Project	<b>IEEE 802.16 Broadband Wireless Access Working Group</b> < <a href="http://ieee802.org/16">http://ieee802.org/16</a> >	
Title	<b>MBS AES-CTR text change</b>	
Date Submitted	<b>2004-08-17</b>	
Source(s)	JUNHYUK SONG, YONG CHANG, JICHEOL LEE  Samsung Electronics	Voice: +82-31-279-3639 <a href="mailto:junhyuk.song@samsung.com">junhyuk.song@samsung.com</a>  Voice: +82-31-279-3639 <a href="mailto:jicheol.lee@samsung.com">jicheol.lee@samsung.com</a>
Re:	IEEE P802.16e/D4-2004	
Abstract	Proposal for MBS AES-CTR text change	
Purpose	Review and Adopt the suggested changes into P802.16e/D4	
Notice	This document has been prepared to assist IEEE 802.16. It is offered as a basis for discussion and is not binding on the contributing individual(s) or organization(s). The material in this document is subject to change in form and content after further study. The contributor(s) reserve(s) the right to add, amend or withdraw material contained herein.

## AES-CTR clarification

Figure-1 MAC PDU formats

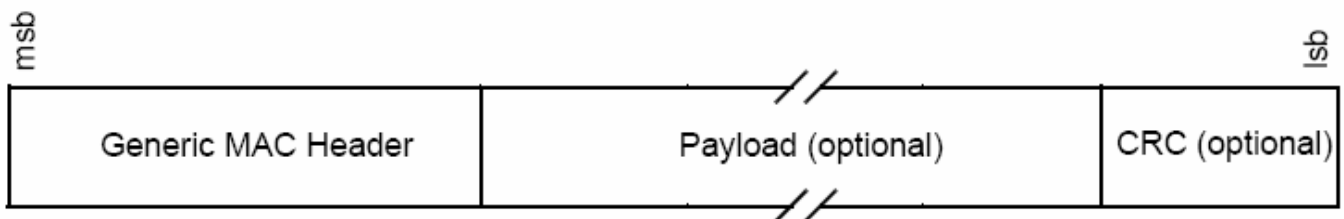
802.16 specified big-endian byte ordering in Generic MAC header (see figure 1), and it is a basic assumption for packet format and other attribute has more than one octet. However AES-CTR specified little-endian ordering for nonce. It is desirable to have big-endian byte ordering for nonce transmission for sake of consistency with GMH and other packet formats

The PDU payload shall be appended with 32bits nonce randomly generated by base station. The nonce shall be transmitted in ~~big~~little endian byte order. The nonce shall not be encrypted.
